## **BUCKLEY CITY COUNCIL STUDY SESSION AGENDA**

To: Mayor Pat Johnson  
Members of the Buckley City Council  
From: Planning Commission  
Date: July 12, 2016  
Re: Design Guidelines

**CITY OF BUCKLEY**  
**DRAFT RAINIER GATEWAY SUBAREA PLAN**

Figure 4: Zoning in the SR410 Subarea

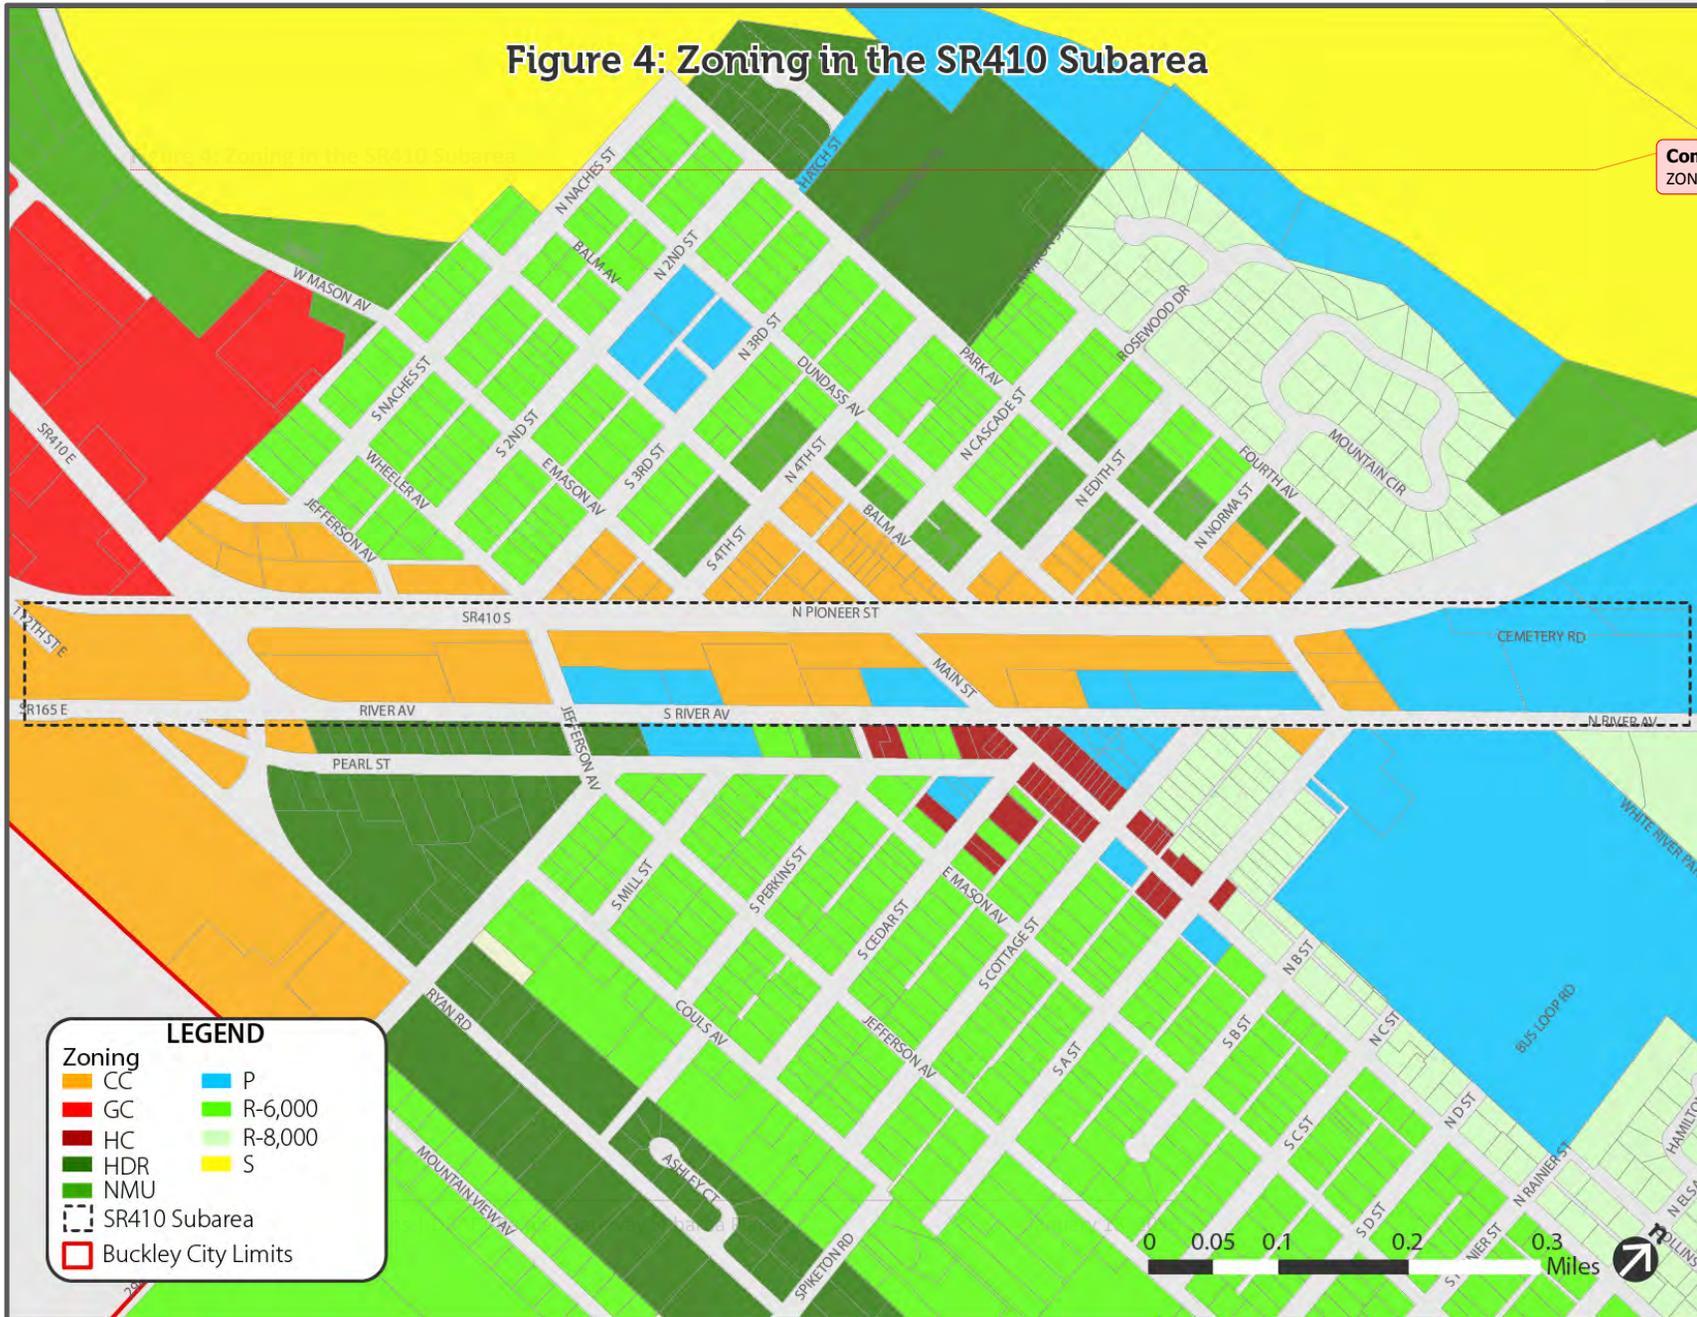
Comment [kj2]: NEED TO ADD UPDATED ZONING MAP
